VILLAGE OF WINNETKA

Winnetka Design Review Board

Regular Meeting

Case No. 15-10-PD: Preliminary Review of Planned Development Application by Stonestreet Partners and Winnetka Station LLC, for the properties at (a) 511 Lincoln Avenue, (b) 513-515 Lincoln Avenue, (c) 710-732 Elm Street, (d) 740 Elm Street and (e) a Portion of the Adjacent Lincoln Avenue Right-of-Way

PREVIOUS
BRICK

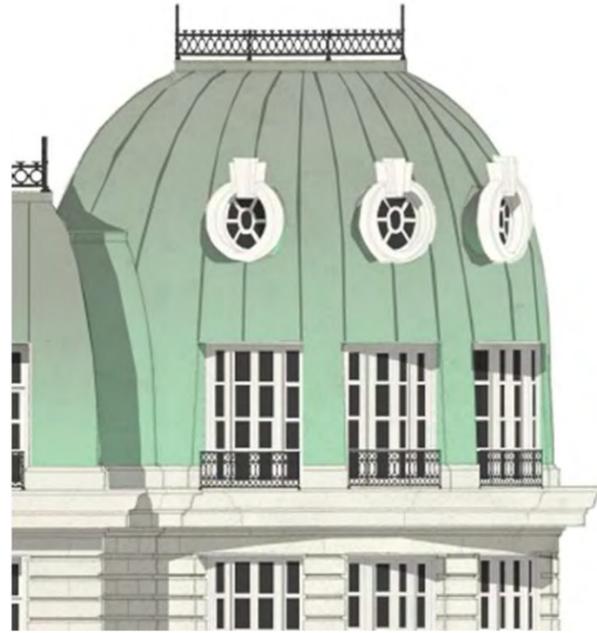
- (P. Konstant): Consider different color for west building.
- (P. Konstant): Consider, dark iron railings, slate colored roof.
- (K. Albinson): Is scale and architecture of west building hard, formal, cold?
- (K. Albinson): Is ornamentation of proposed Elm Street facades too extensive?
- (K. Albinson): Is west parking garage in accordance with Village design aesthetic?
- (K. Albinson): Request for rendering from top of Elm Street bridge.
- (B. Dearborn): Clarification of height of proposed west building relative to existing building across street to north.
- (B. Dearborn): Clarification of height of 710 Elm parking structure relative to sidewalk.
- (B. Dearborn): Clarification of project boundaries and extent of landscaping on public property west of 711 Oak St.
- (P. Stanley): Questioning use of different materials.

COPPER
BRICK

PROPOSED WEST GARAGE FACADE

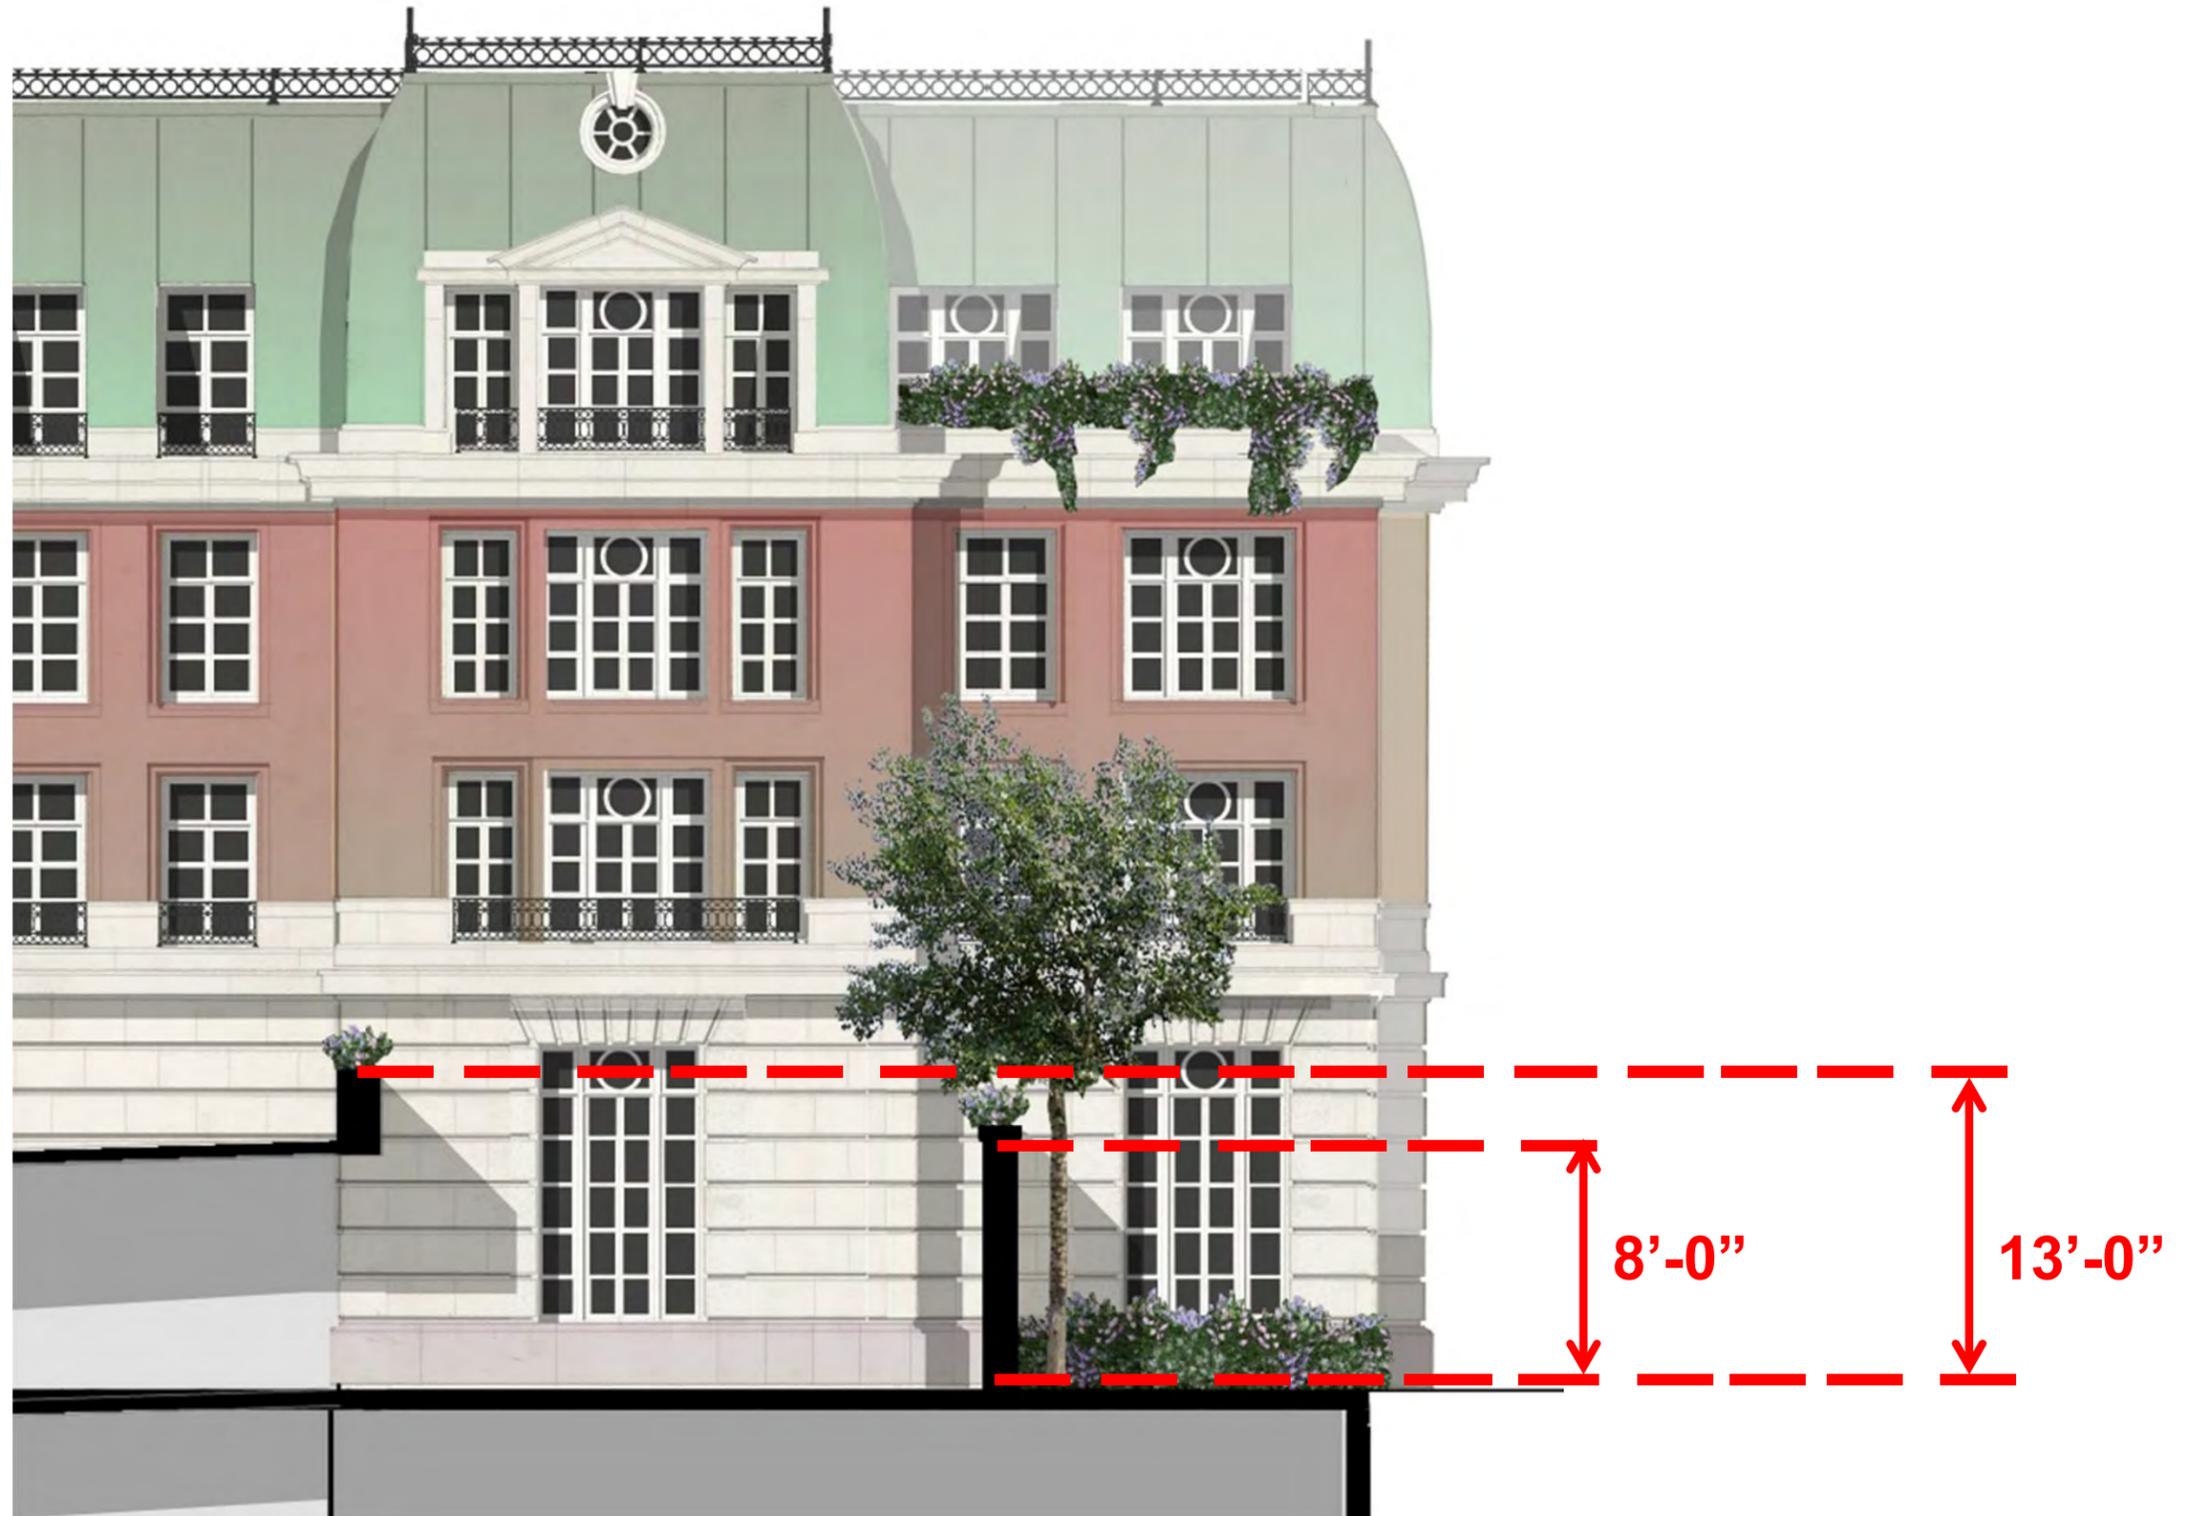
- Is west parking garage in accordance with Village design aesthetic?
(K. Albinson)

VIEW FROM ELM STREET BRIDGE

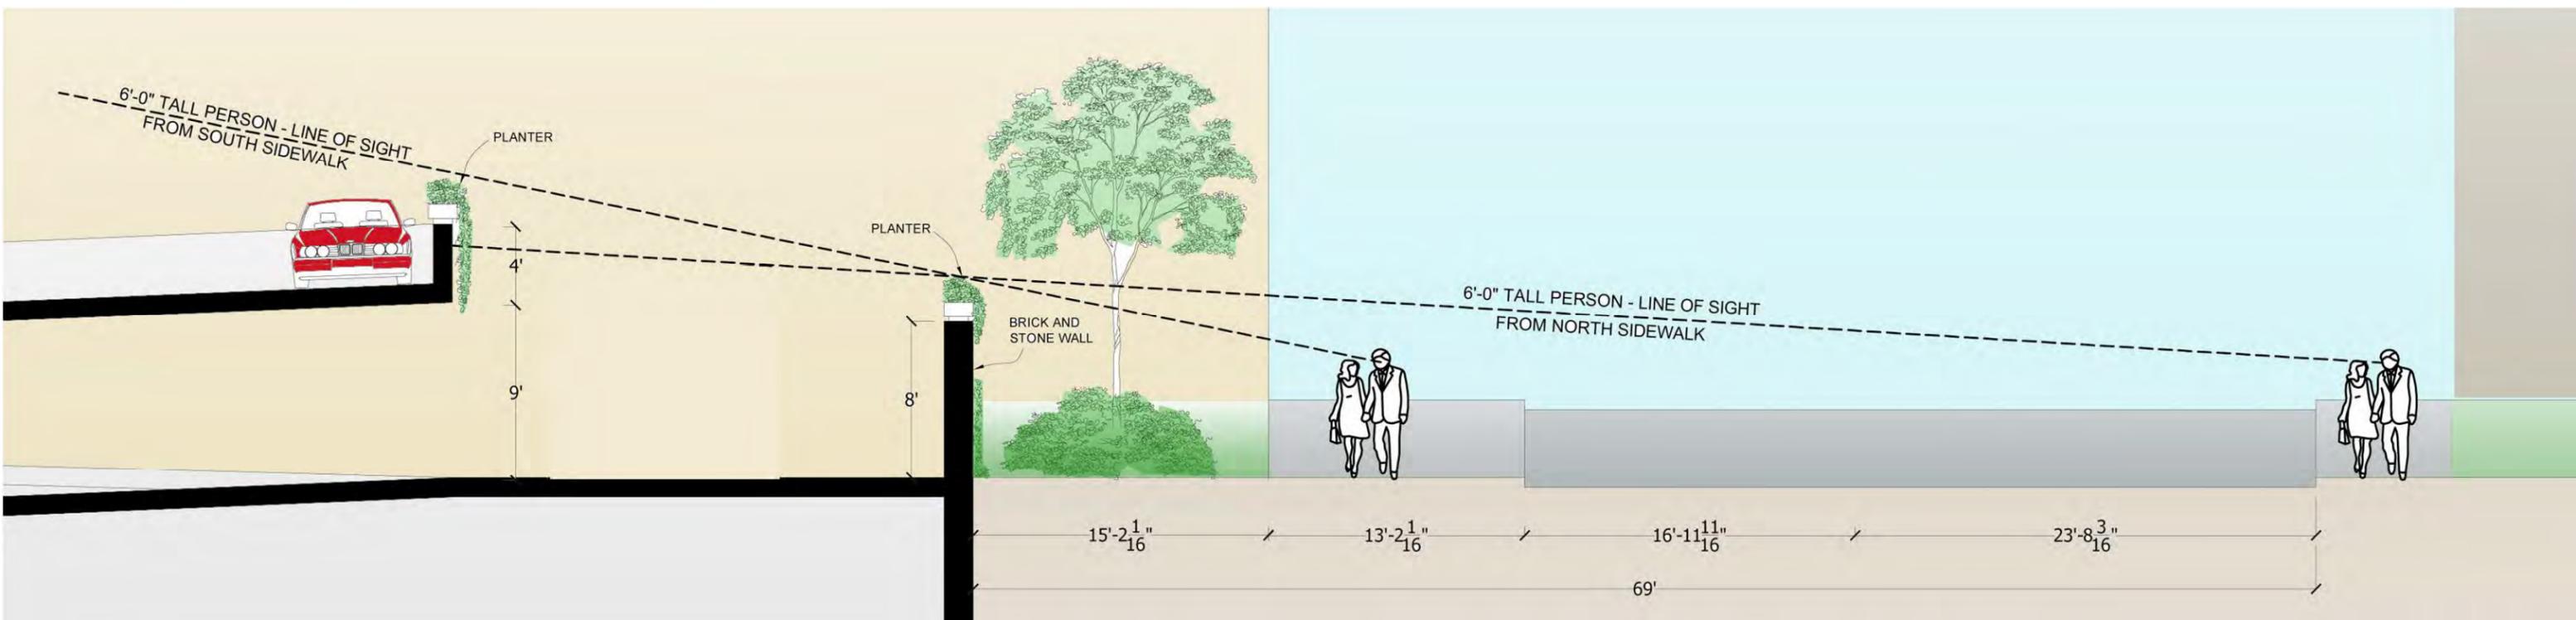
- Request for rendering from top of Elm Street bridge. (K. Albinson)

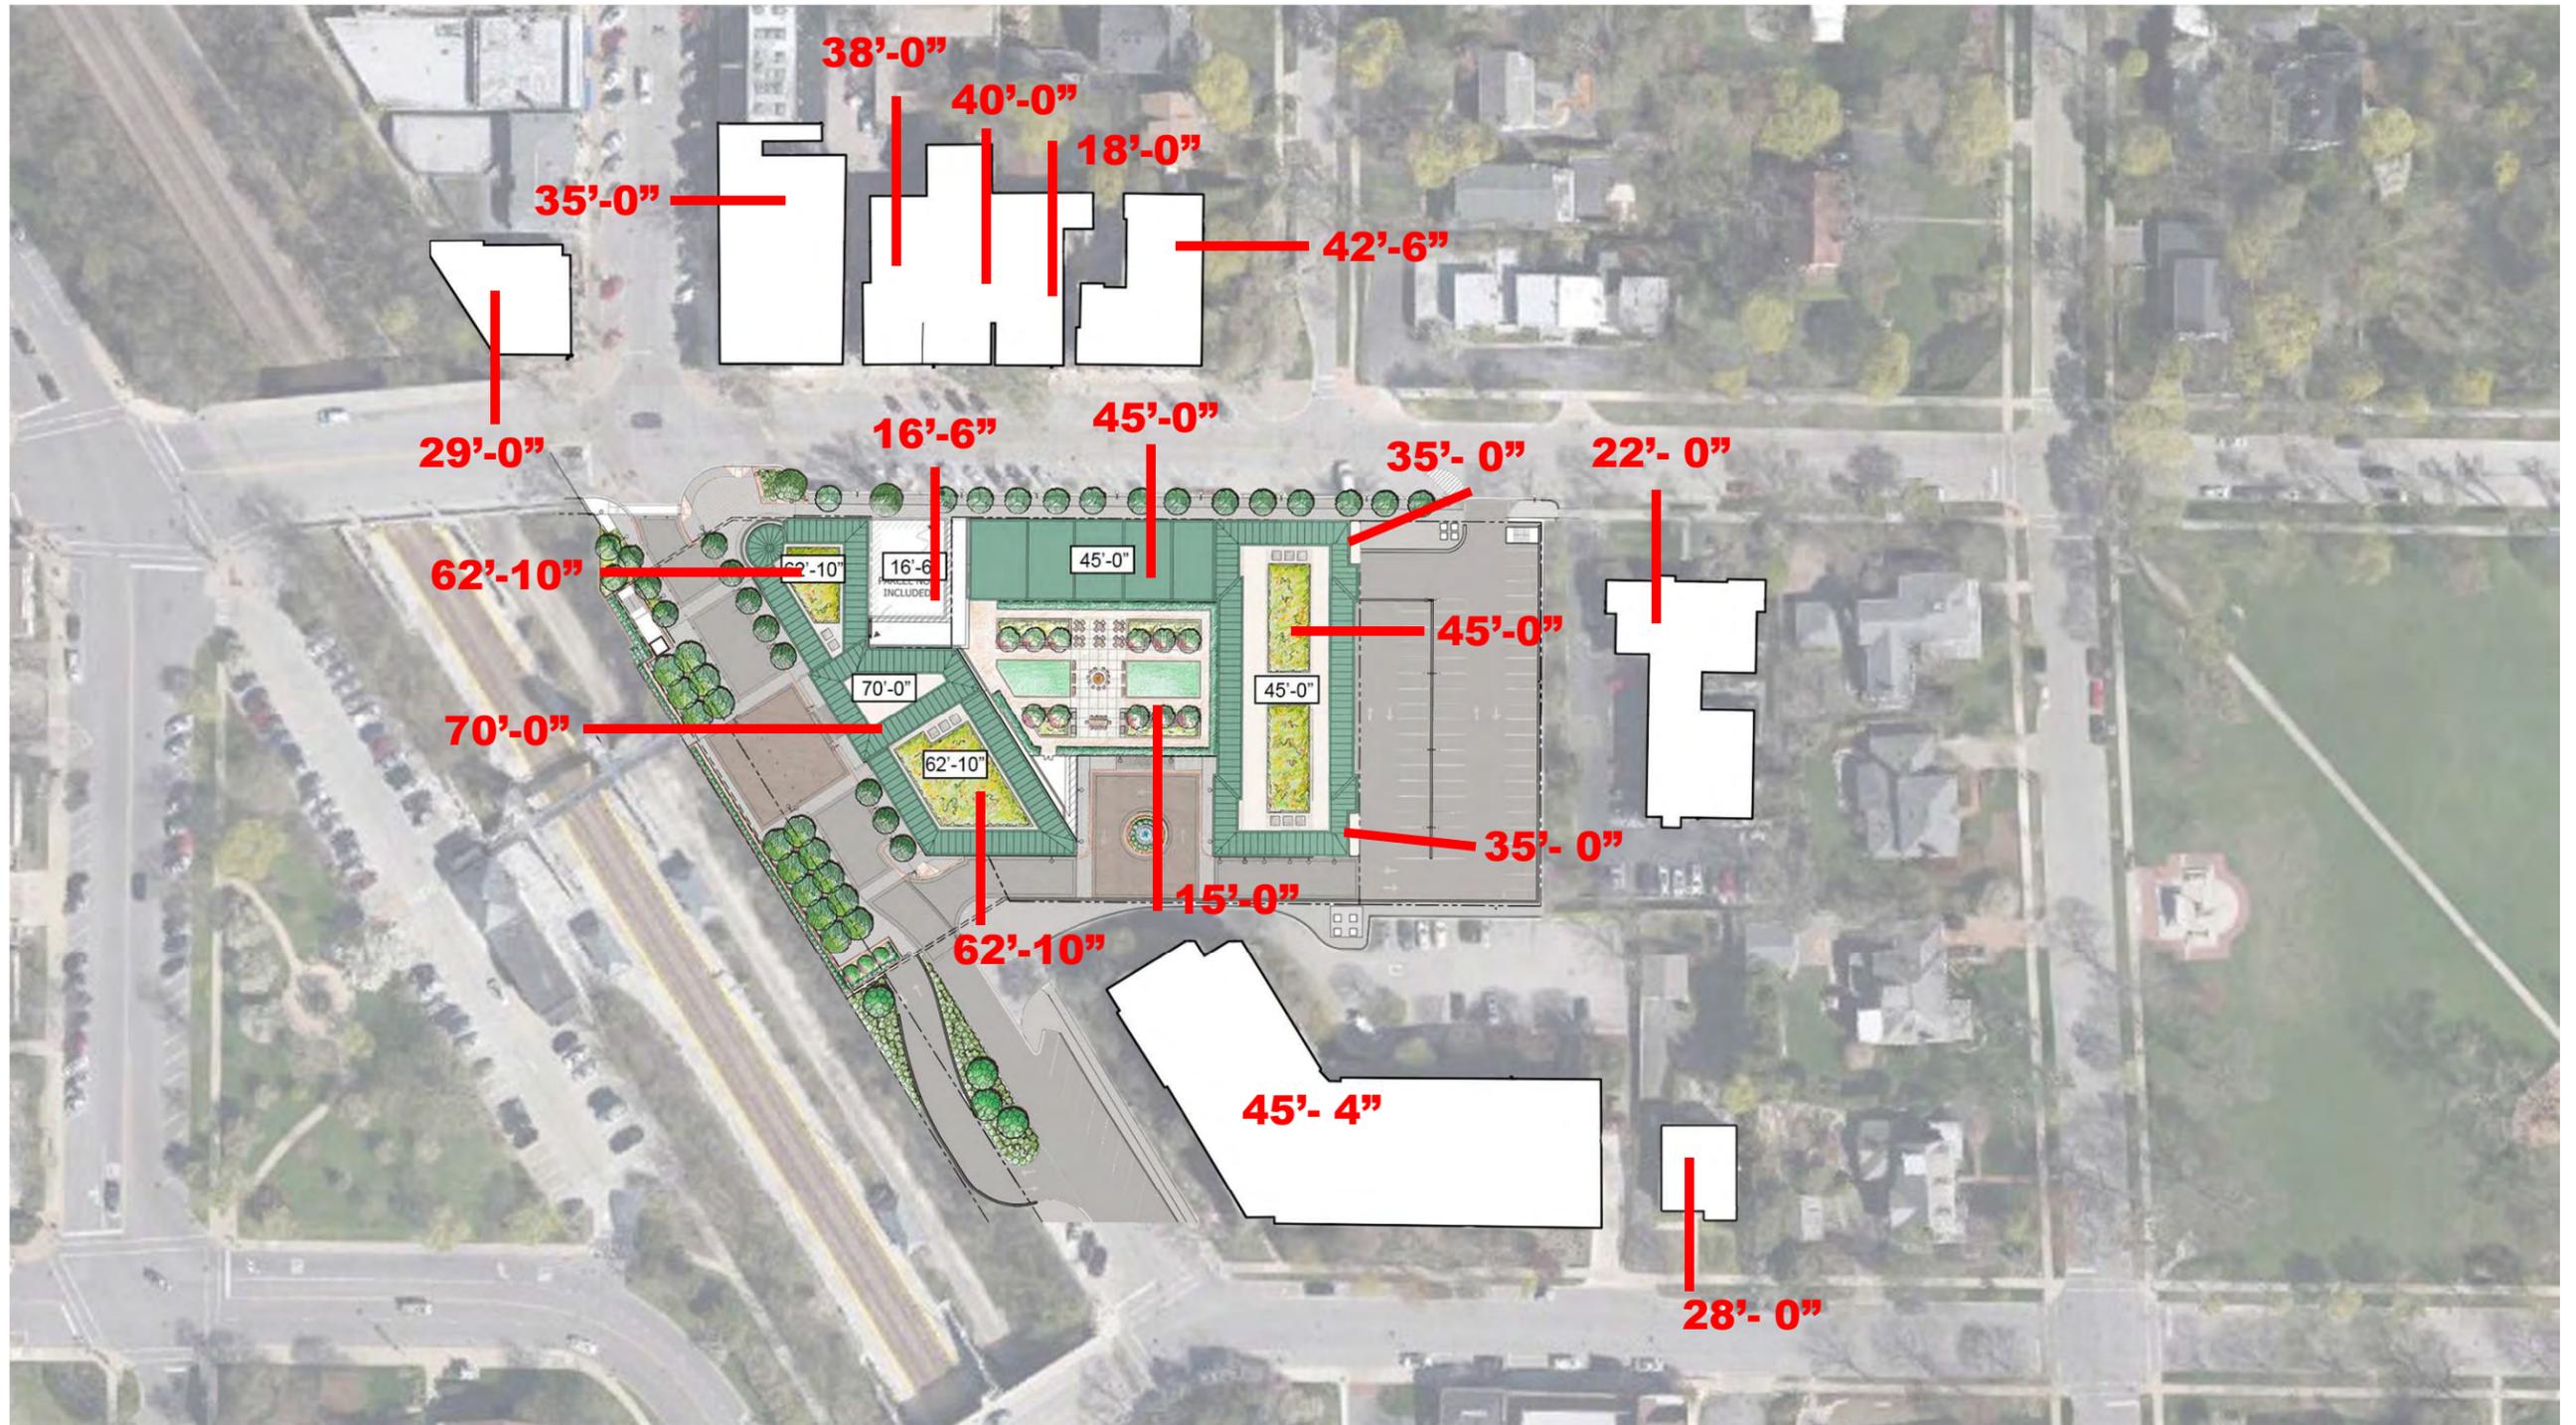
- Clarification of height of 710 Elm parking structure relative to sidewalk. (B. Dearborn)
